Access Compliance Report

Public Rights-of-Way

Intersection ID: 44916	Main Street: FOX_POINT_DR	Cross Street: BERRYBROOK_LN	Location: NW
ADA ID: 969D968E0700	Ramp Type: PerpDiag	Initial Pass/Fail: Fail	Overall Compliance: No
		Severity Score: 17.5

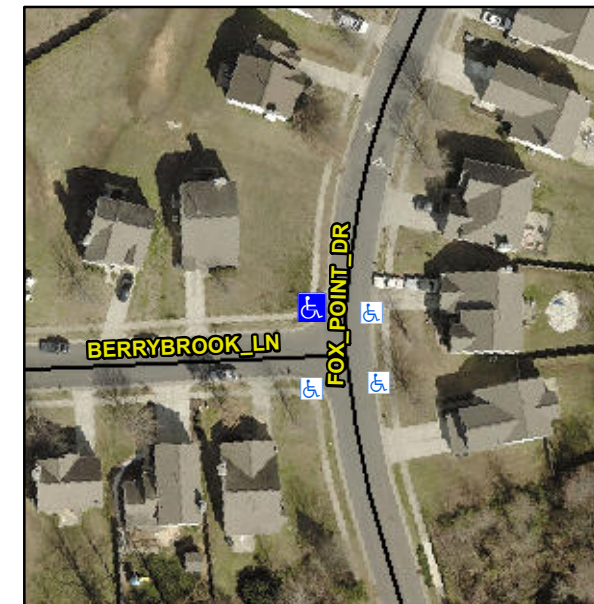
R304.5.1

Compliance	Description	Data	Compliance	Description	Data
N/A	Ramp Length (in)	53.0	Yes	Ramp Slope (%)	6.3
No	Ramp Width (in)	35.0	Yes	Ramp XSlope (%)	1.6
N/A	Flare Type LT	N/A	N/A	Flare Type RT	N/A
N/A	Flare Slope LT (%)	N/A	N/A	Flare Slope RT (%)	N/A
N/A	Flare Traversable LT?	N/A	N/A	Flare Traversable RT?	N/A
N/A	Landing Length (in)	N/A	N/A	DWS Provided?	N/A
N/A	Landing Width (in)	N/A	N/A	DWS Contrast?	N/A
N/A	Landing Slope (%)	N/A	N/A	DWS Length (in)	N/A
N/A	Landing X Slope (%)	N/A	N/A	DWS Full Width?	N/A
N/A	Landing Curb? (Y/N)	N/A	N/A	DWS Offset (in)	N/A
N/A	Shared Landing?	N/A			
N/A	Gutter Ponding?	N/A	N/A	Gutter Slope (%)	N/A
N/A	Gutter Lip Ht (in)	N/A	N/A	Gutter X Slope (%)	N/A
N/A	Painted X Walk1?	No	N/A	Painted X Walk2?	No
	X Walk 1 Direction	To S		X Walk 2 Direction	To E
N/A	X Walk 1 Width (in)	N/A	N/A	X Walk 2 Width (in)	N/A
	X Walk 1 Slope (%)	1.7		X Walk 2 Slope (%)	4.5
	X Walk 1 X Slope (%)	4.4		X Walk 2 X Slope (%)	2.9

Remove & Replace Curb Ramp With Two New Directional Ramps or Equivalent.
